**Town of Kittery
Planning Board Meeting
January 11, 2024**

ITEM 1—181 State Road—Marijuana Business Plan — Preliminary Review

**RE: Preliminary Site Plan Review – Review Revisions
Indico Adult-Use Marijuana Retail
181 & 185 State Road, Kittery, Maine (Tax Map 28, Lot 14-2)**

**RE: Town of Kittery, Planning Board Services
Indico Adult-Use Marijuana Retail Review
181 & 185 State Road (Tax Map 28, Lot 14-2)
CMA #591.170**

OVERALL SITE PLAN
INDICO CANNABIS RETAIL
181 & 185 STATE ROAD, KITTERY MAINE

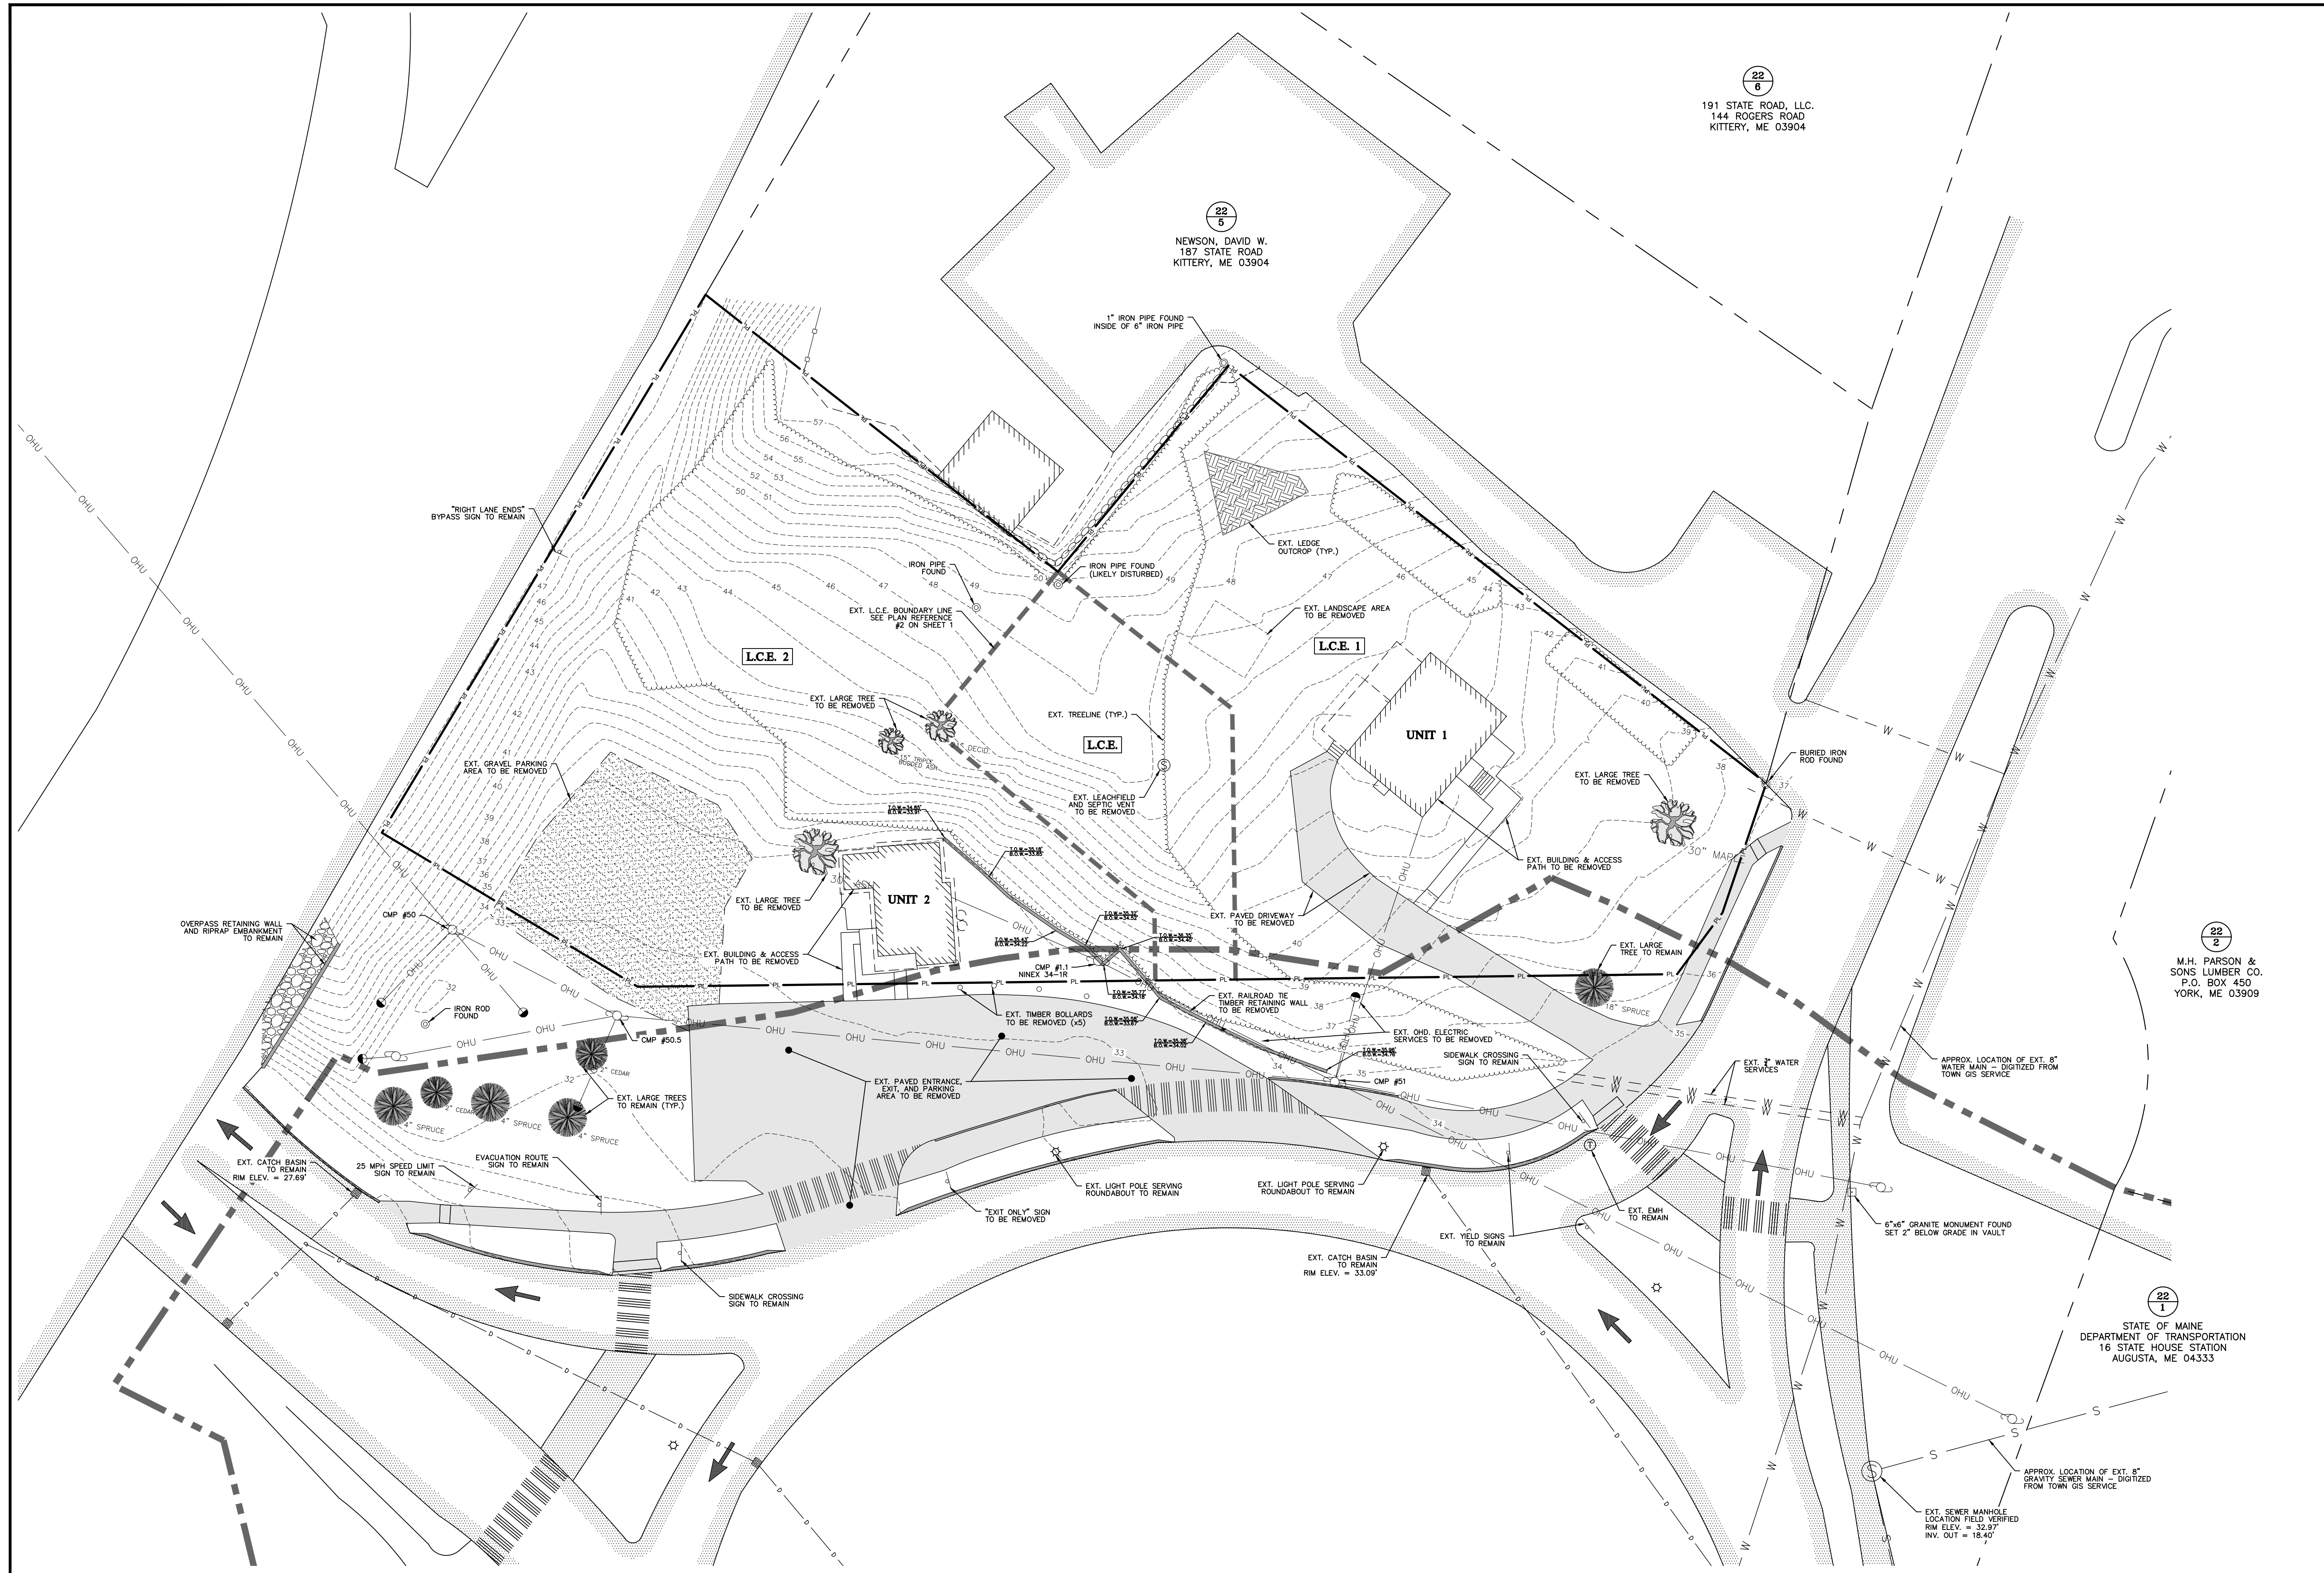
Sheet 1 – Overall Site Plan

1. General Notes 2 incorrectly references Map 22, Lot 4.
2. The parking spaces should be dimensioned (or one as a typical).
3. General Note 14 indicates snow storage is shown on the plans, but it is not.
4. Amend General Note 11. Kittery Water District is not Town water.

- General Note #3 on Sheet 1 has been revised to remove the minimum lot size typo. This same note has also been revised to remove certain landscaping requirements that no longer apply now that the entire parcel will reside within the C-3 zone.

- General Note #4 on Sheet 1 has been revised to include a calculation for tree planting requirements based on the different applicable ordinance sections, which have been summarized in General Note #12.

- Sight Distance measurements have been added to Sheet 1 as requested. All measurements exceed the required minimum stopping sight distance of 200'.
- Snow Storage locations exist on Sheet 1 of the Plan Set to coincide with General Note #14, but have been added to Sheet 3 (Grading & Utilities Plan) as well.

- Typical parking space callout exists on Sheet 1, but dimensions have been added to demonstrate compliance. Similar dimensions and typical callout have also both been added to Sheet 3 (Grading & Utilities Plan).

- General Note #11 on Sheet 1 has been revised to appropriately reflect utility service information.
- Sheet 2 (Existing Conditions Plan) has been revised to have all callouts reflect the removal or retention of various elements including paved entrances, exits, parking areas, existing large trees, retaining walls, etc.

EXISTING CONDITIONS PLAN
INDICO CANNABIS RETAIL
181 & 185 STATE ROAD, KITTERY MAINE

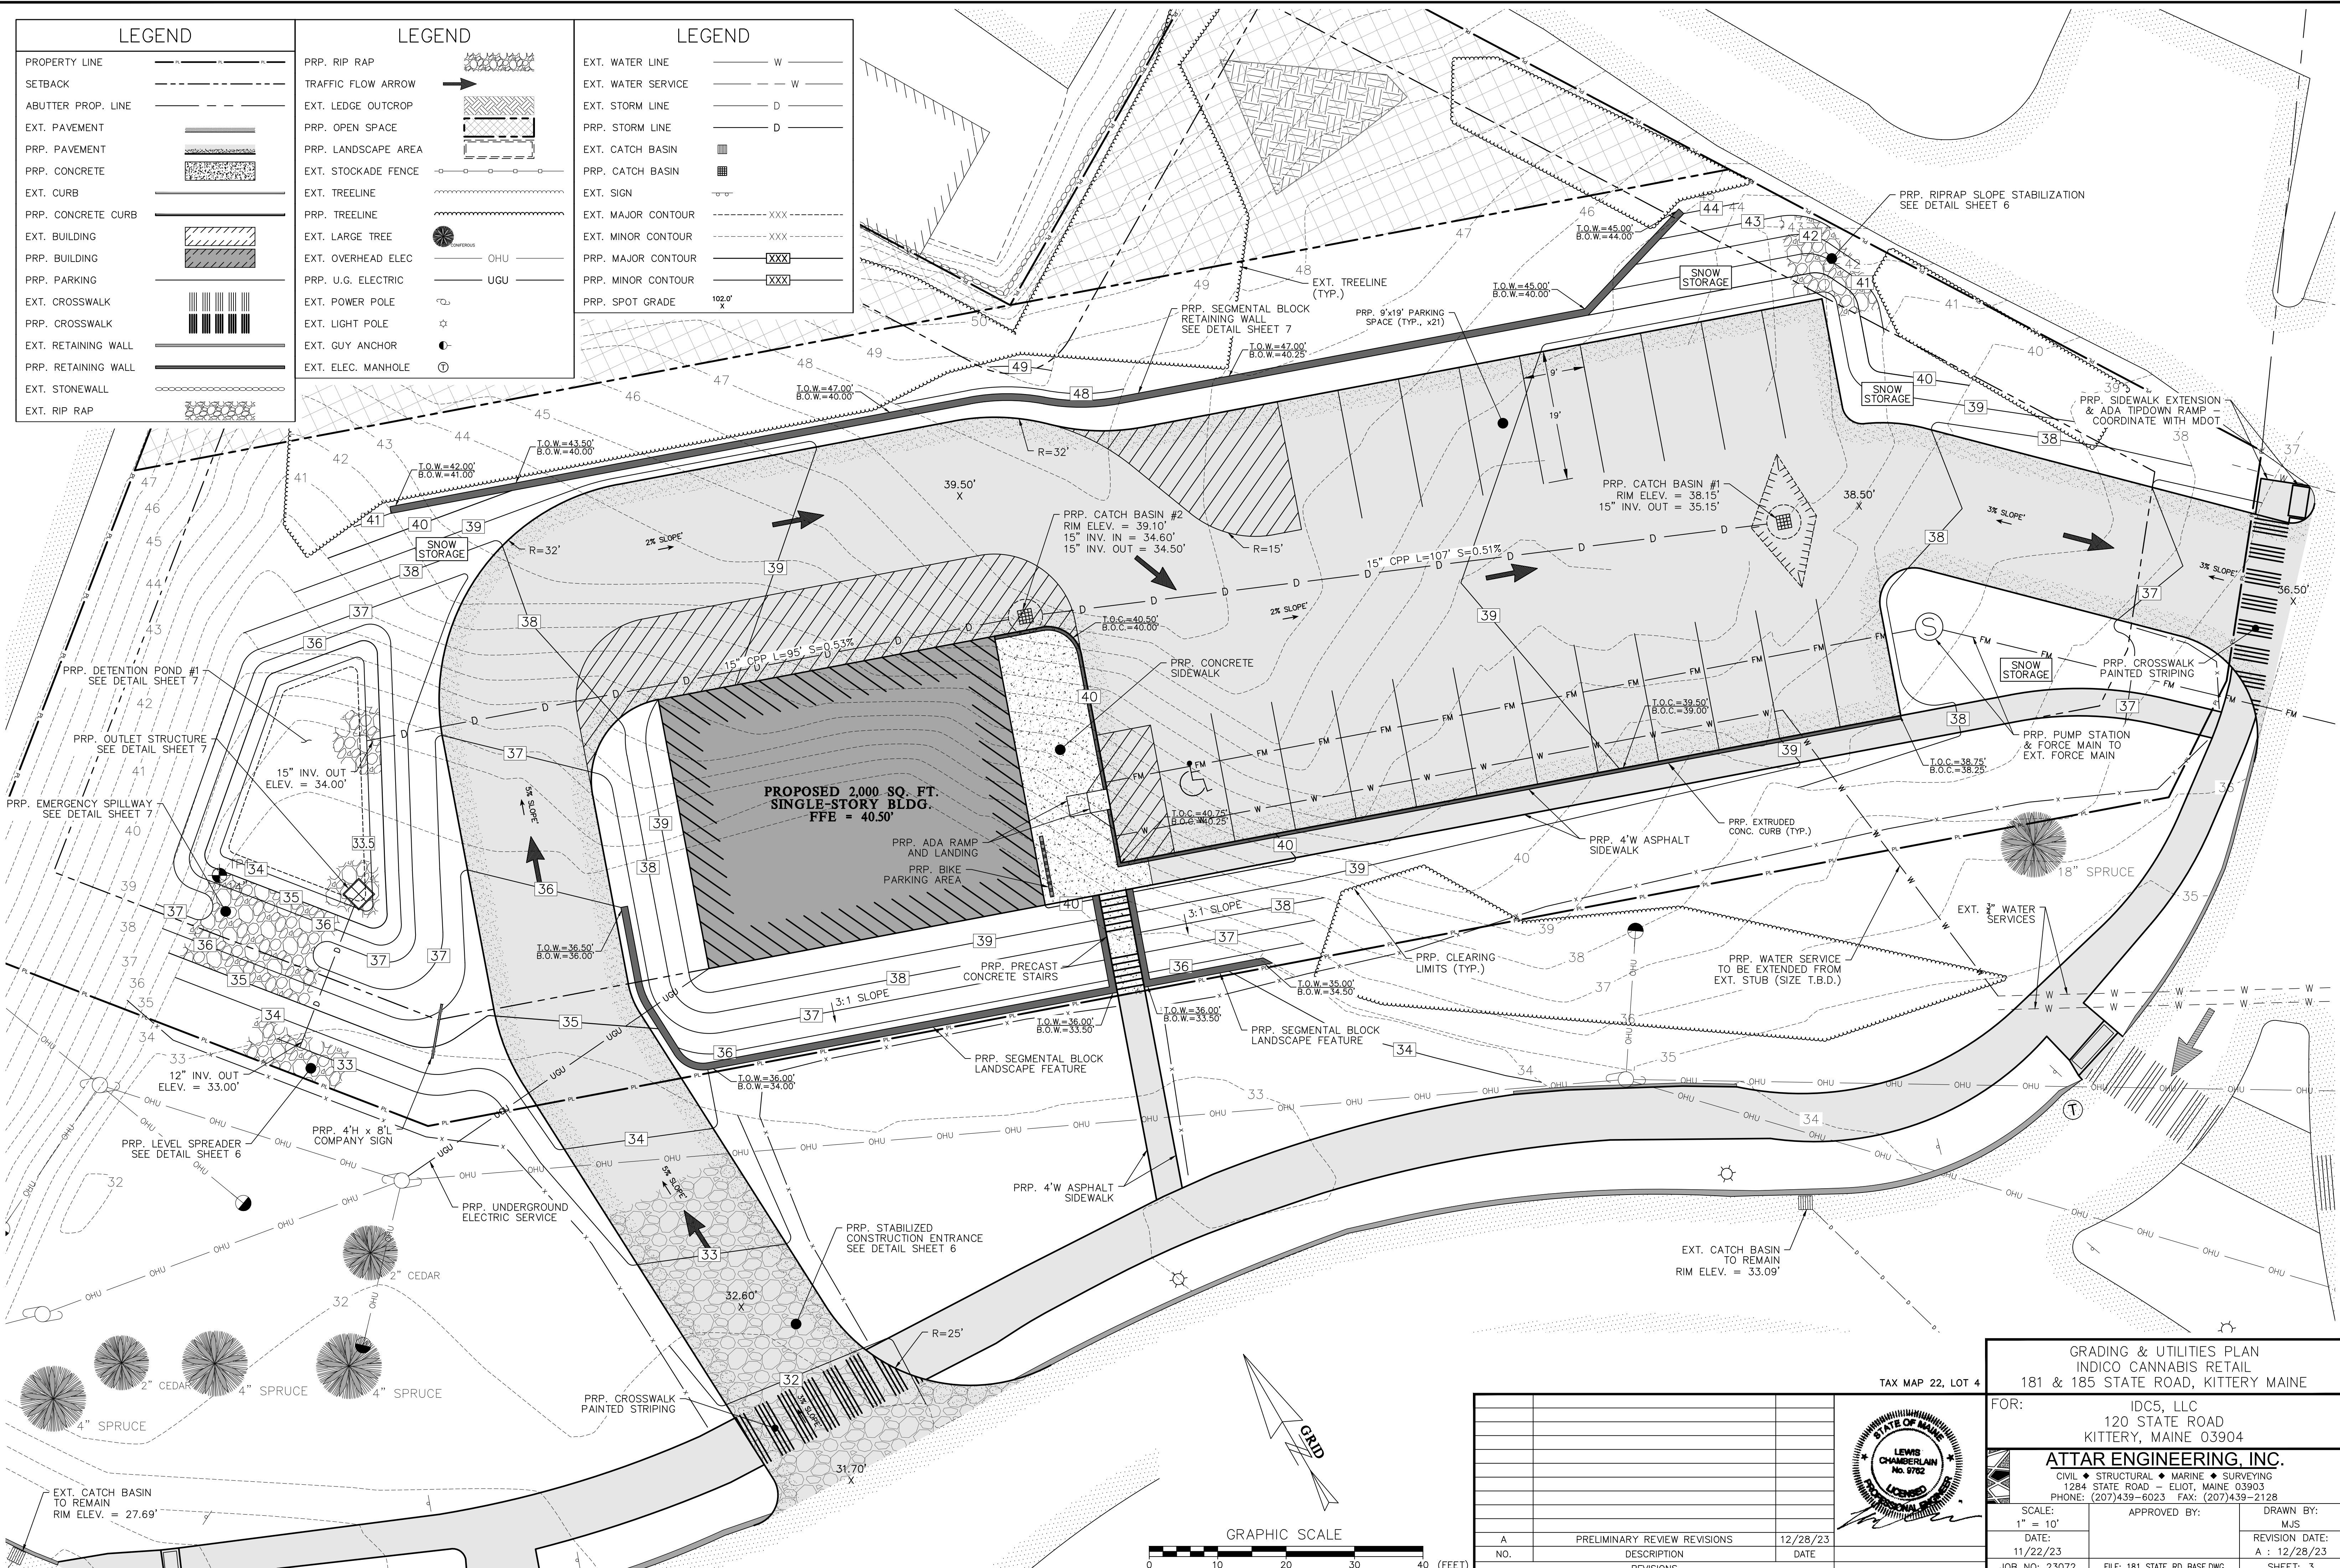
Sheet 2 – Existing Conditions Plan

1. The plan should indicate that both driveways are to be removed.
2. The plan should show the location of all existing water and sewer mains and services including sizes and materials.
3. The plan should indicate whether the spruce trees are to be removed or to remain.
4. The label “Ext. LCE Boundary Line See Plan Reference #_” is incomplete.
5. The plan should indicate whether the “Overpass Retaining Wall and Riprap Embankment” are to be removed or to remain.
6. The label “Sidetalk (sic) Crossing to Remain” should be corrected.
7. The plan should define “L.C.E.”.
8. There is an existing leach field and septic vent shown. Where is the septic tank located? Is it proposed to remain in place? If so, the plans should contain information about emptying the tank and filling it with gravel or dirt.

- Sheet 2 (Existing Conditions Plan) has been revised to have limited common element callouts appropriately reference the Plan References notes on Sheet 1. Additionally, a notes section has been added to Sheet 2 to define L.C.E. (Limited Common Element).

GRADING & UTILITIES PLAN
INDICO CANNABIS RETAIL
181 & 185 STATE ROAD, KITTERY MAINE

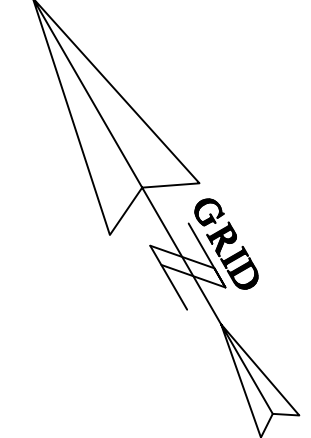
Sheet 3 – Grading and Utilities Plan

1. Is the “Prp. Segmental Block Landscape Feature” the same as the “Prp. Segmental Block Retaining Wall”? If so, the leader should reference the detail on Sheet 7. If not, please provide a detail.

9. The water service and sewer service both stop at the concrete sidewalk.
10. The plan should show the location of the curb stop and sewer clean out (if required).

11. The plan references an Emergency Spill detail on Sheet 7 but there is no detail.

- Sheet 3 (Grading & Utilities Plan) has been revised to differentiate callouts for the proposed segmental block retaining wall to be constructed north of the travelway and parking lot. Callouts now reference the retaining wall detail included in Detail Sheet 7.
